B.W.I.P.
ES-1 SEALING
CONSIDERATIONS

February 9, 1983

Rockwell Hanford Operations Richland, WA 99352 ENGINEERING ORDER		EO TYPE		QA Level	Change Type	Building	Project No.	EO 00195		
			Release		Supersedure	I	-	800-G	B-314	Priority Is A Cross Reference To AUTHORIZATION NO. WBS LF2222 CEI - CM014
		X	Release To File		Cancellation	Cognizant Engineer		Phone		
			Authorize Requirements		Obsolescence	J. S. Ritchie (KE/PB) 415-271-5281				
			Change		File As Drawing	Responsible Organization		Phone		
						R. M. Ybarra	376-6204	N

Concept for Detail 2 of
Drawing HB-S20901

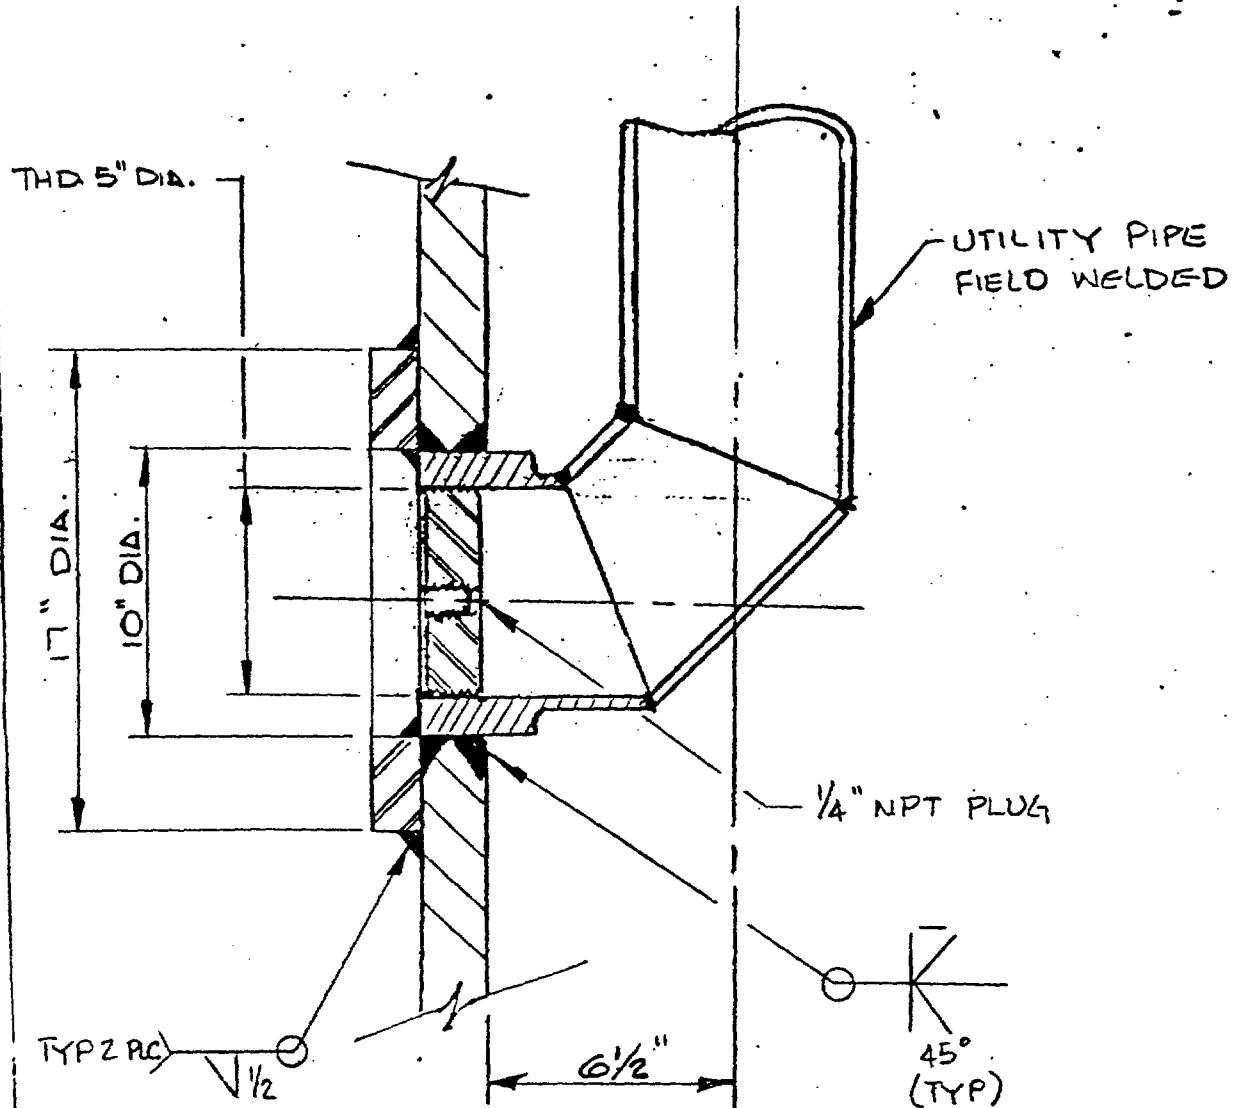
Detail 2 - Replace Detail 2 with Figure 1 (attached) *add*
~~add the following note: Supplier is to provide utility collar and plugs. Welding to casing will be provided by others - show all welds as field welds. Justification: location of utility lines may change depending upon the horizon selected.~~

Detail 8: Same change as detail 2 of drawing H8-S20901.
